#### **CALIFORNIA COASTAL COMMISSION**

# 5-11-302-A2 (CITY OF NEWPORT BEACH) AUGUST 13, 2021

**CORRESPONDENCE**

Subject: Supplemental Comments: Appeal No. A-5-NPB-21-0026 (City of Newport Beach)

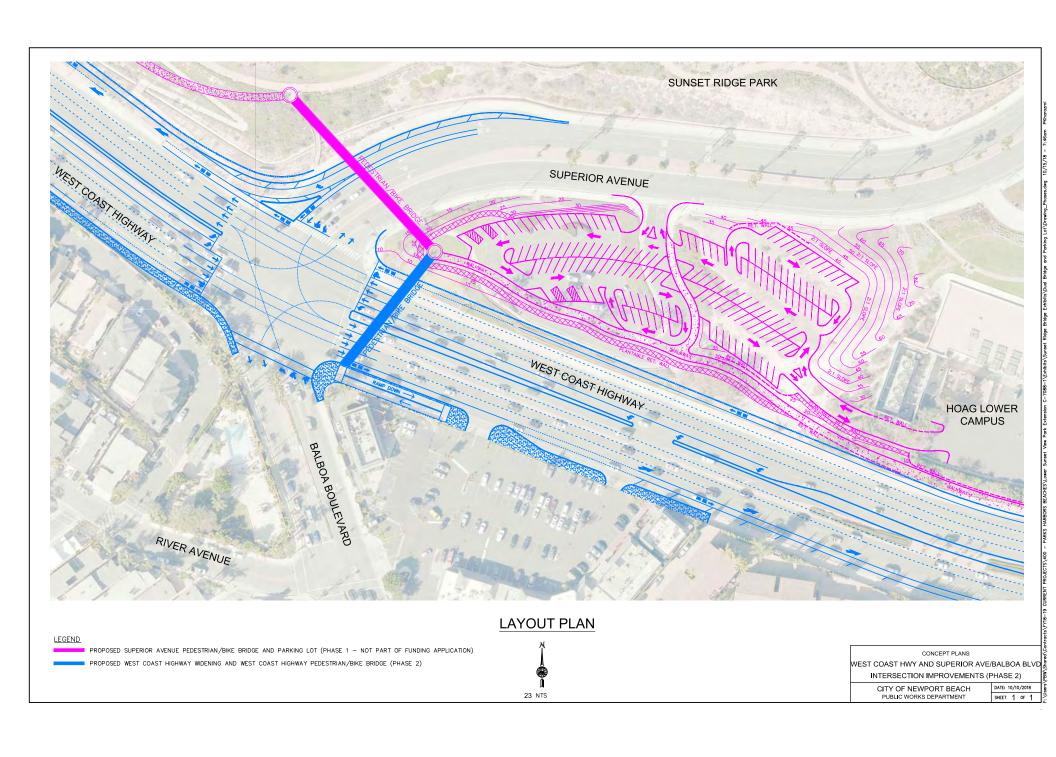
- 1. Community supports Additional public parking and access. The Community supports the idea of additional public parking and access to coastal resources including Sunset Ridge and Sunset View Parks, but not if the additional parking and access is part of the widening of West Coast Highway at Superior Avenue.

- 2. Community concern The removal of public access. The community has become aware of a larger project, "the West Coast Highway and Superior Ave/Balboa Blvd Intersection Improvement Plan" and is concerned that if this project is approved, the existing public sidewalks and crosswalk at Superior Avenue will be removed and the public will have no choice but to cross Superior Avenue and WCH by bridge which will be an inconvenience for pedestrians and bicyclists and a hardship for children in strollers; the disabled and handicapped. The proposed bridges have no elevator access. Bothe sides of the Superior bridge are accessed by long zig zag walkways. This project represents Phase 1 of the larger project. The removal of public sidewalks and crosswalks will occur in Phase 2. Phase 2 cannot proceed if Phase I is not constructed.

- 3. Community concern The project is part of a larger project not being discussed. Since 2014 the city, in coordination with Caltrans and OCTA, has been developing detailed plans for the widening of the intersection of Superior Ave and Pacific Coast Highway.<sup>1</sup> These improvements implement the long-range (2040) California Transportation Plan (CTP) required by federal and State law. The CTP is incorporated in the Orange County Master Plan of Arterial Highways and incorporated in the City General Plan, Circulation Element. Figure 1 provides a copy of the West Coast Highway and Superior Ave/Balboa Blvd Intersection Improvement Plan.
